SUMMARY INDEX
HISTORIC DISTRICTS REVIEW BOARD
 May 24, 2016

MINUTES OF THE
CITY OF SANTA FÉ
HISTORIC DISTRICTS REVIEW BOARD

May 24, 2016

STEP BACK PLAN - ATTACHMENT #3

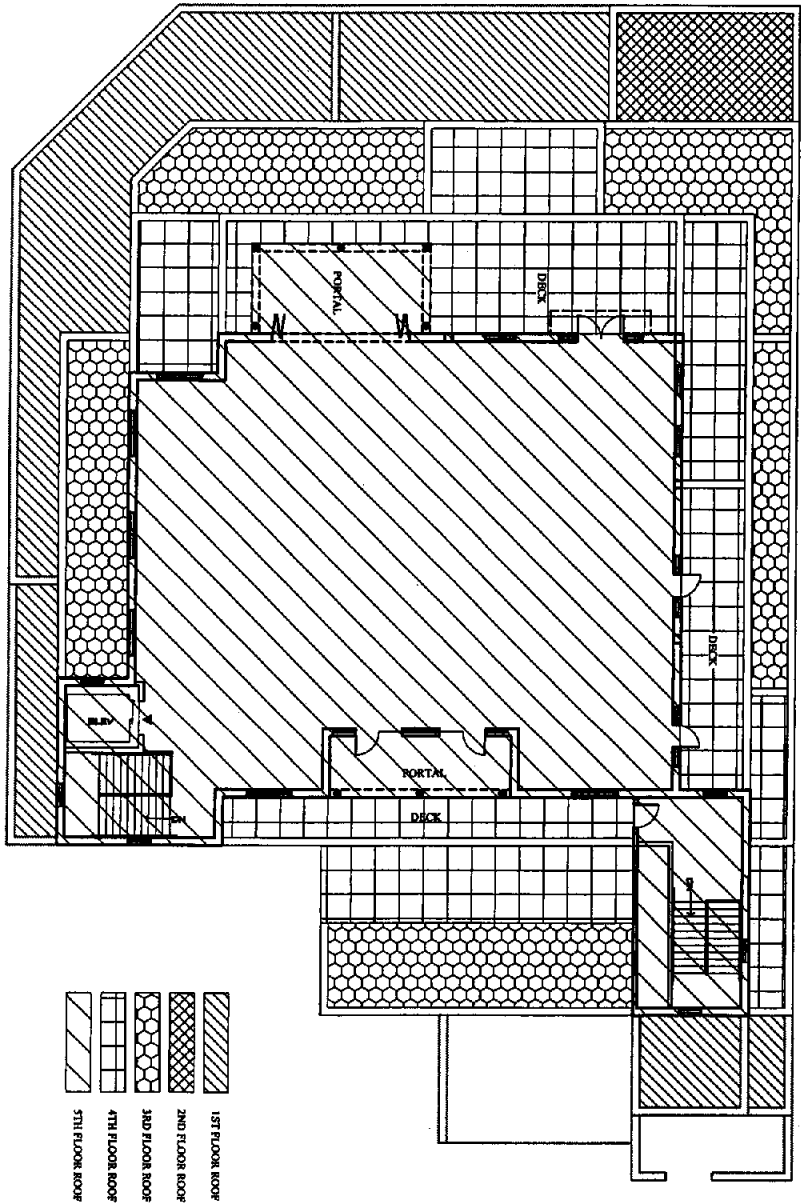
Member Powell moved in Case #H-04-076 at 201 Old Santa Fe Trail, to find the height exception not met and ask the applicant to resubmit a three-story building with suggested step backs, a massing model to include the Loretto Chapel and the Inn at Loretto and drawings and a rendering

Attachment #4

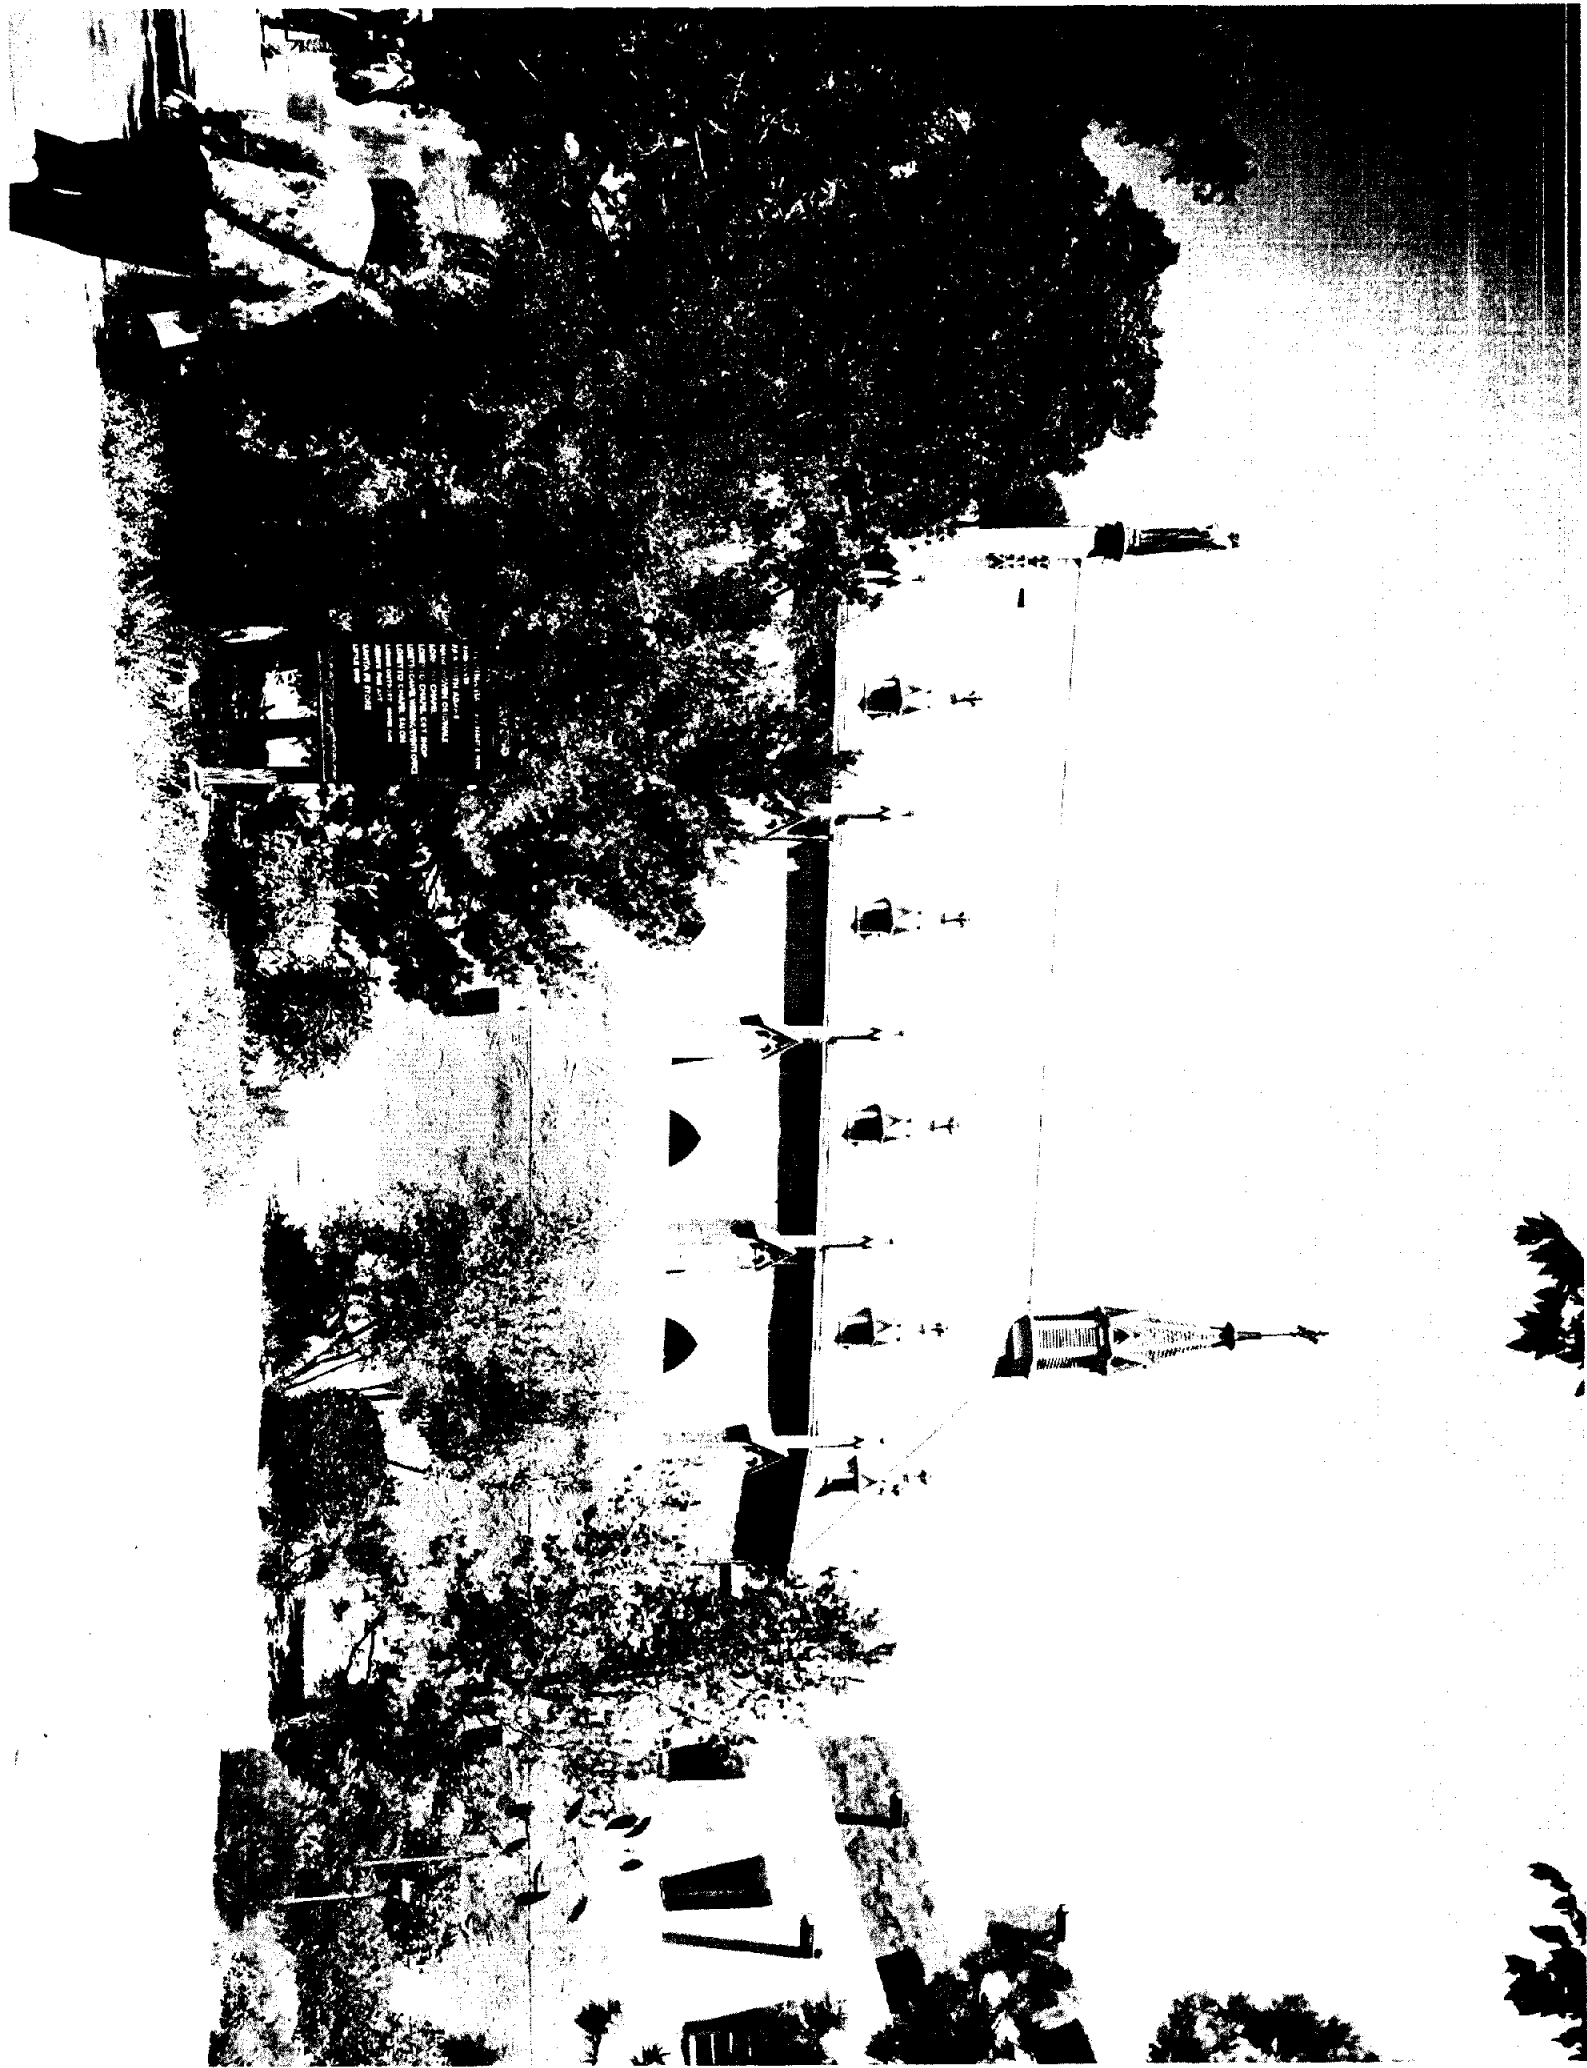
Mr. Enfield's next handout highlighted how important the height issue is [The 21' 11" elevation is attached to these minutes as Exhibit 4]. He was not able to present this 5-story application in July and now understood why - the height ordinance is going to apply. To address the Staff concerns on exception questions that he answered, he was happy that Staff agrees with three of the six criteria. He would address those that Mr. Rasch did not agree with.

Member Katz said design is part of height. He thought Mr. Enfield intended to bring in the drawing of the 21' 11" height as a joke but he didn't think it is a joke.
